To:	Stephane Robert, Manager, Regulatory Affairs	Date:	January 7, 2016
c:	Guangwen (Gordon) Zhang, Principal Specialist	Memo No.:	001
From:	Nigel Goldup	File:	704-ENG.EARC03000-01
Subject:	Response to Information Request KIA-WL-01: Type A Water Licence Application: Meliadine Gold Project, NU

2.0 RESPONSE REGARDING REVISITING THE OVERBURDEN WITHIN THE WASTE ROCK STORAGE FACILITY

ECHELLE/ SCALE	FICHIER FILE	REVISION	FEUILLE/SHT
No. DESSIN/ DRAWING NO.	.DWG	0	1 / 3
6509-616-210-202-001A

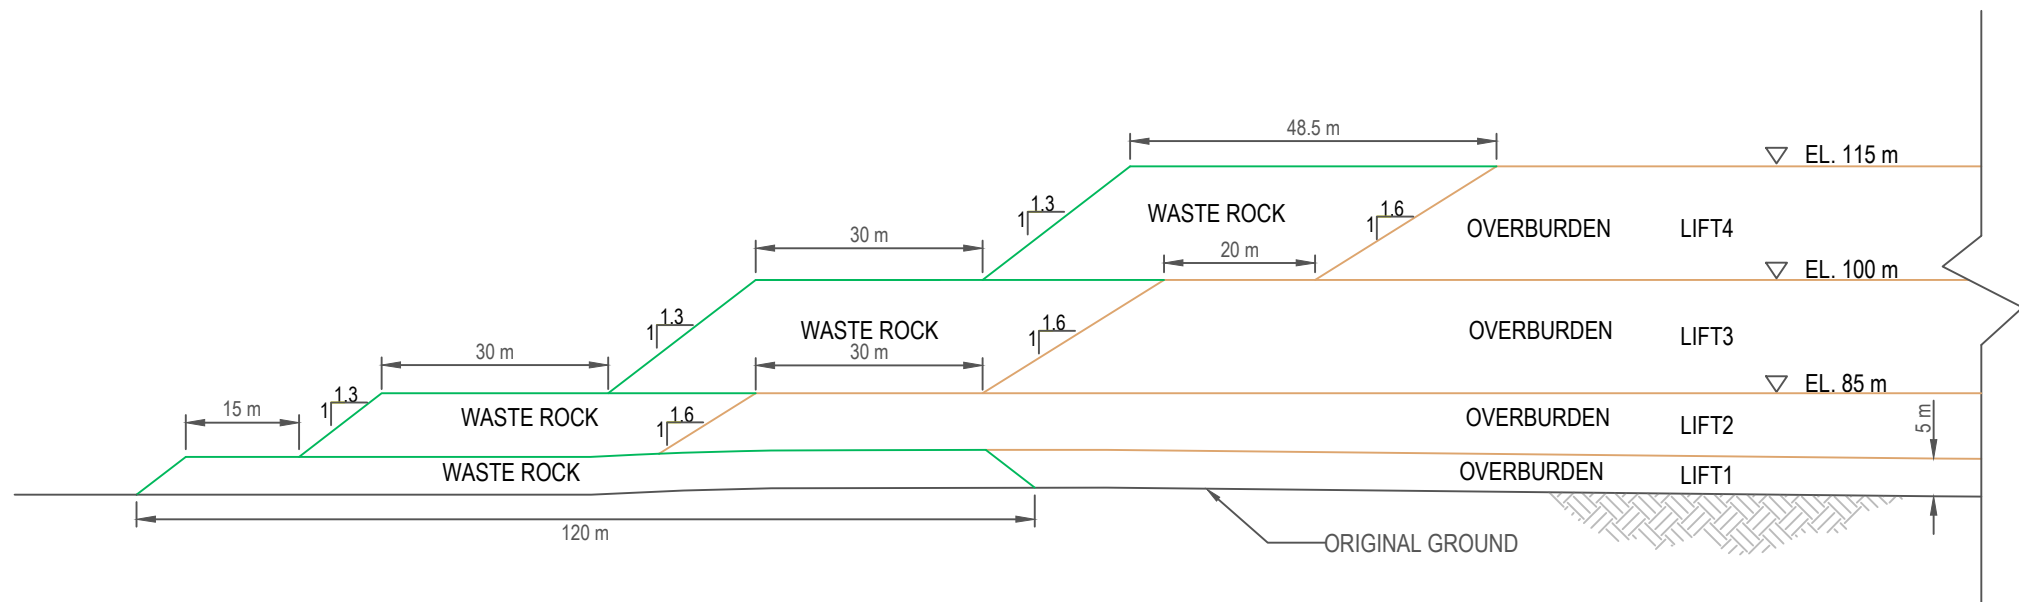
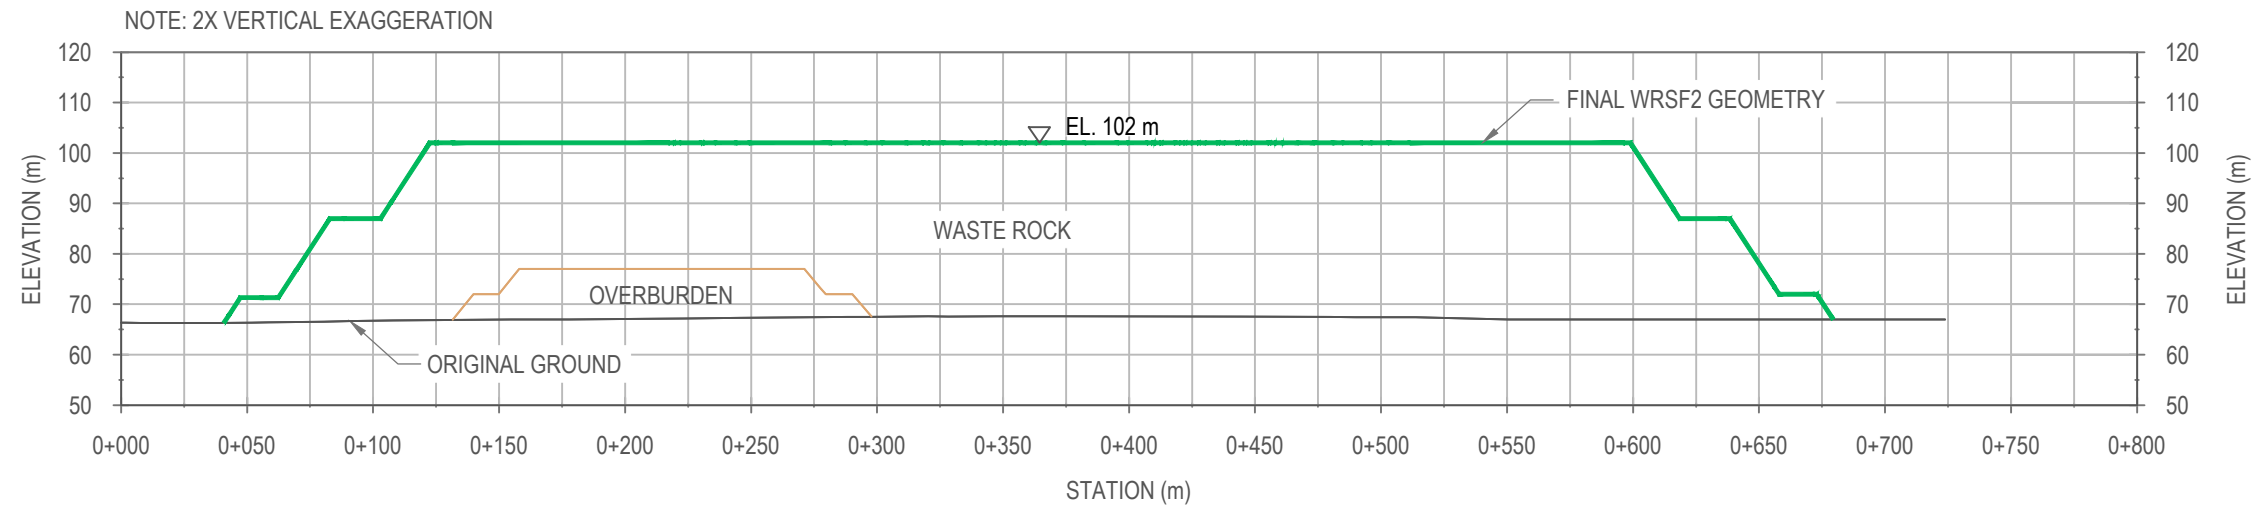
- The natural stable slope of the thawed overburden material is expected to be relatively flat (ranging between 4:1 and 6:1 [horizontal:vertical]). Therefore, storing the overburden at the outer slope would require a significantly larger WRSF footprint when compared to the current waste rock encapsulated footprint that has an outer slope of 2.2:1 to 3:1. The current design has minimised, where possible, the storage footprint by bounding the overburden with more stable waste rock, hence allowing much steeper internal overburden slopes of 1.6:1 as shown on Drawing Number 6509-616-210-202-001A.

- Referring to Drawing Number 6509-616-210-202-001A to -003A, only WRSF1 would be available for this option as the overburden material at WRSF2 and WRSF3 are covered by significant depths of waste rock.

- Later recovery of overburden material from the top of WRSF1 would be possible and calculations indicate that approximately 0.15 M tonnes of this overburden material could be recovered in this manner, assuming an excavated depth of 2 m. However, excavation of overburden material could create a depression in the upper surface, leading to a risk of local ponding and possible retrogressive sloughing of the rear excavation scarp. If the excavation process extends over more than one summer season, the collected water from precipitation (snow melt and rain) may need to be pumped from the excavation before proceeding with future excavations. Having a pond on the top of WRSF1 is not recommended, and could be detrimental to the safety and operation of the facility in the long-term and would need to be managed. One of the main risks is that the pond could promote thaw of the uncompacted overburden beneath the pond, eventually seeping, and cause an uncontrolled discharge of water to the downstream environment through a sinkhole or other breach of the pond containment.

In conclusion, later recovery of overburden material from the top of WRSF1 could be possible but it will require careful management of environmental, water management, operational, and safety risks. This option could yield approximately 0.15 M tonnes.
